Harrell Stream and Wetland Mitigation Site

Monitoring Year 3 (2022)

NCDMS Project No. 100005

Subject: RE: Draft Monitoring Year 3 (MY3) Report for
the Harrell Stream and Wetland Site
Little Tennessee River Basin – CU# 06010203– Jackson County
DMS Project ID No. 100005
Contract # 007006

MY3 Supplemental Planting
 Harrell Mitigation Site
 Jackson County, NC
 December 2022

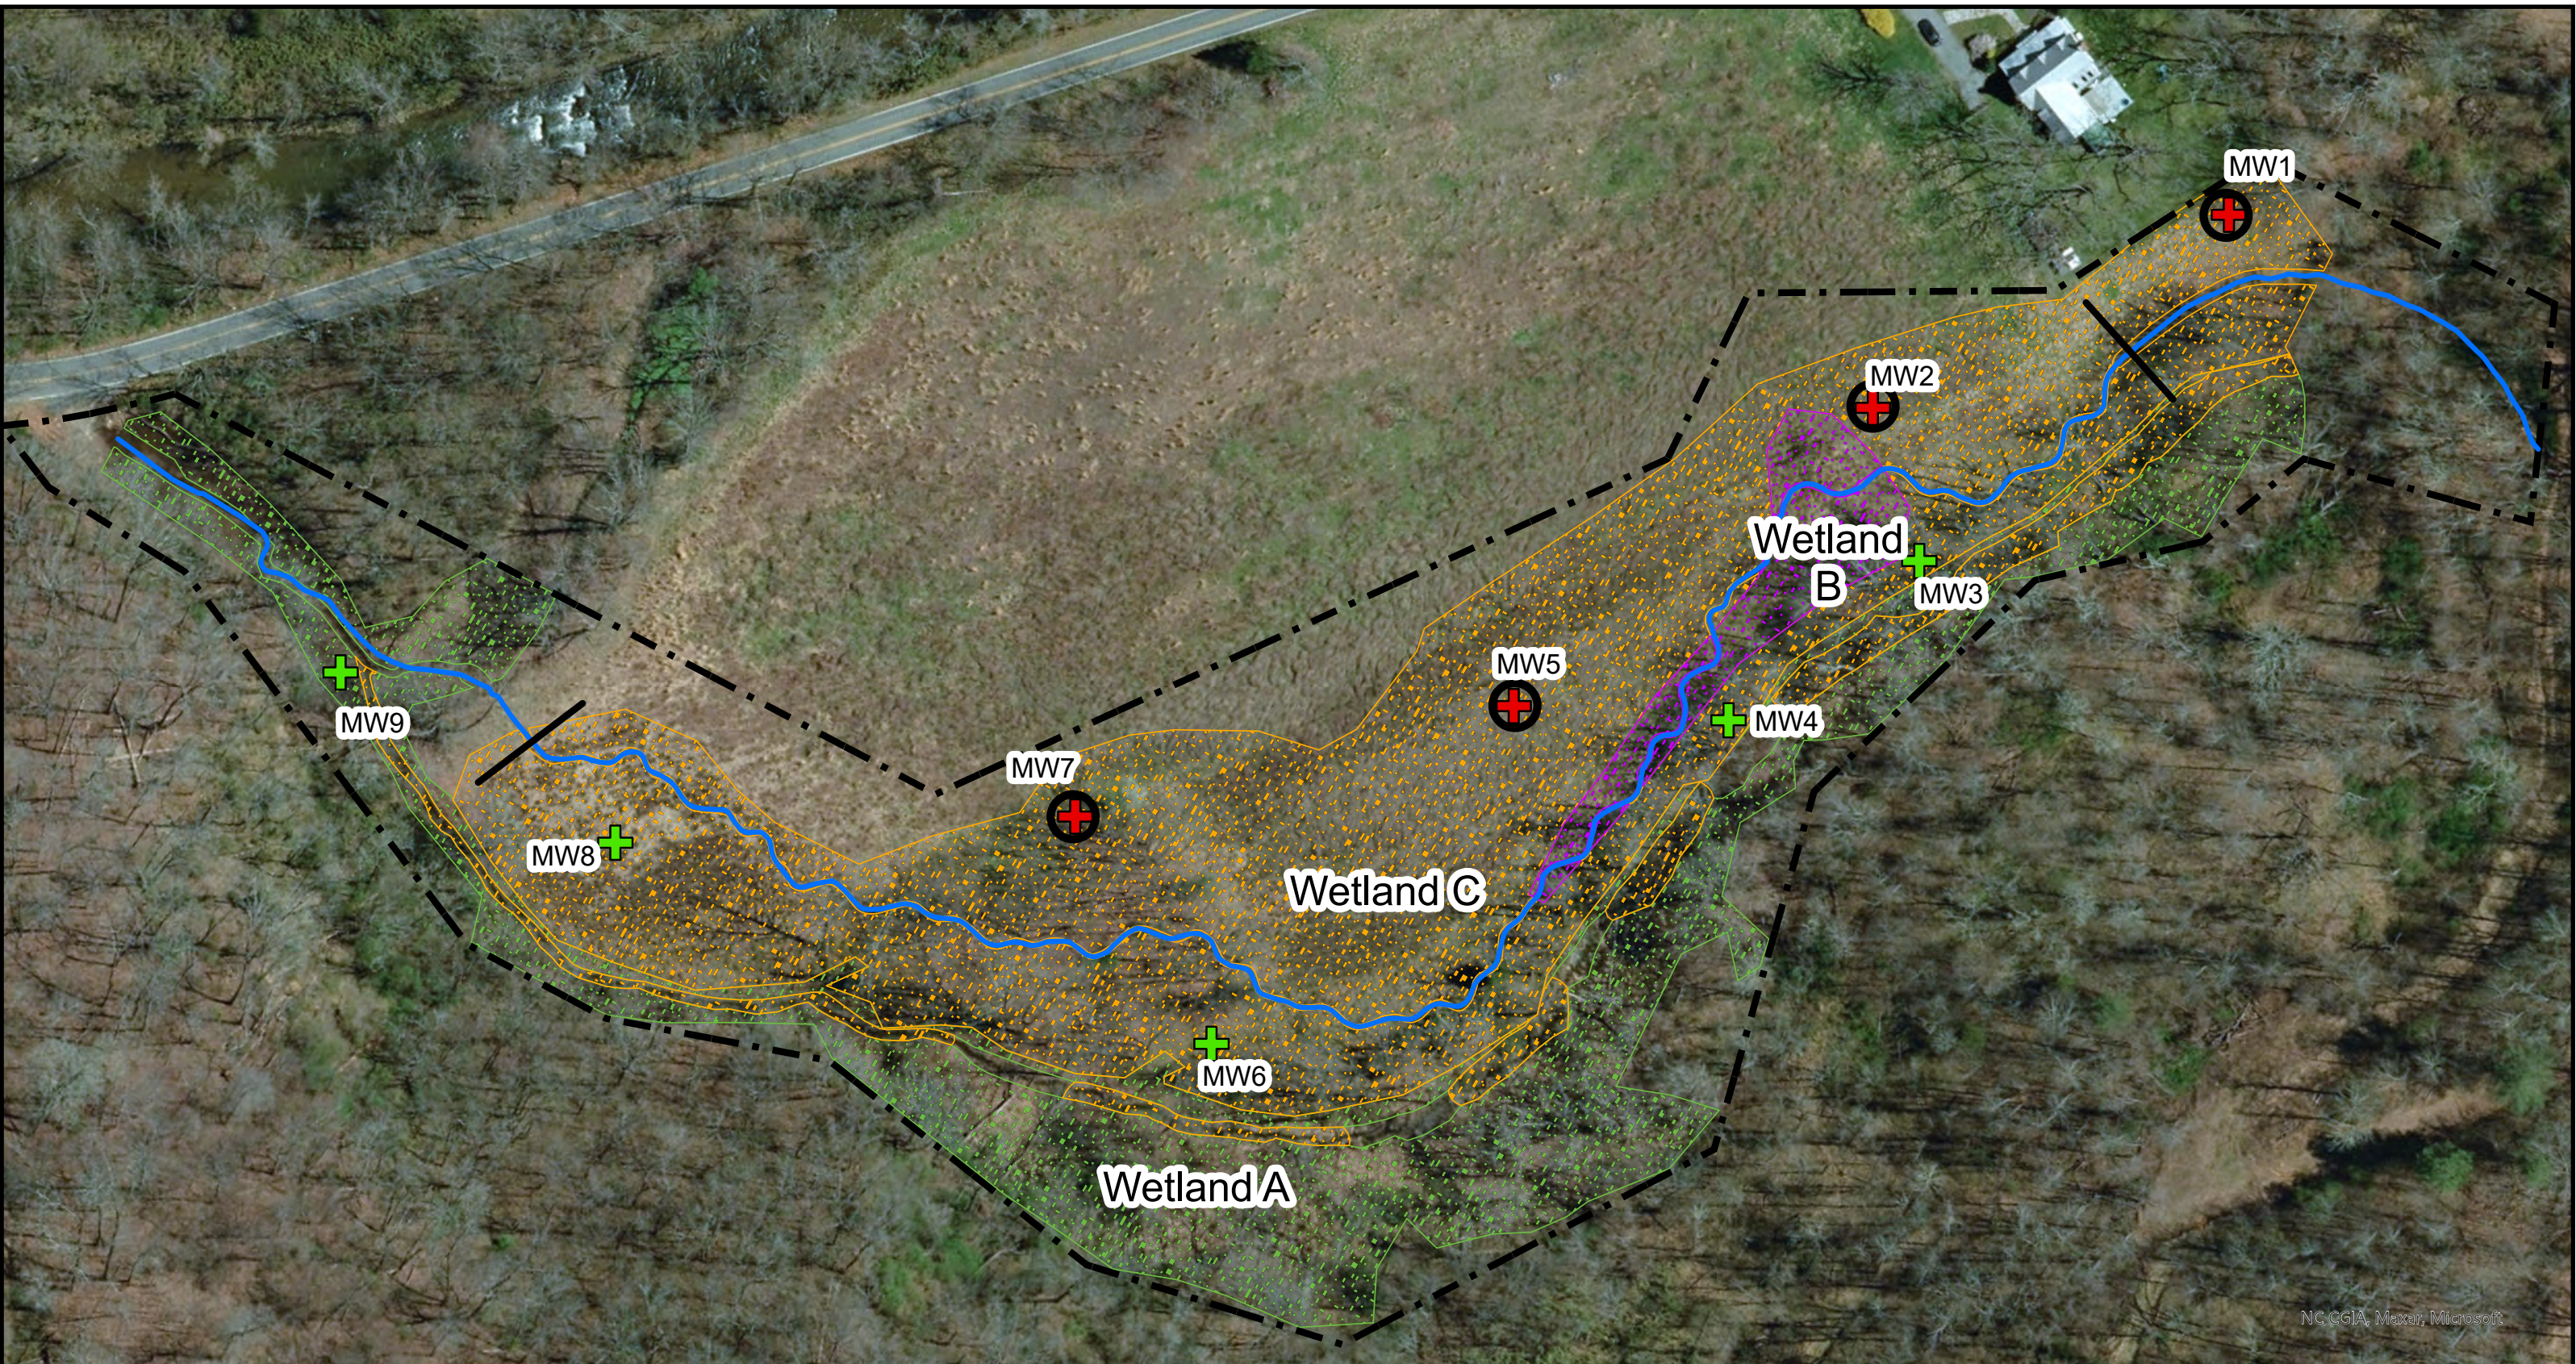
Section 1.5.1. Vegetation: *“A map and summary of the supplemental plantings can be found in Appendix F.”* Only the supplemental planting summary is available in Appendix F. Please review and update the report accordingly. DMS recommends including a 2022 supplemental planting map in the appendix and additionally showing the area/s on the MY3 (2022) CCPV Map. **Added to Appendix F.**
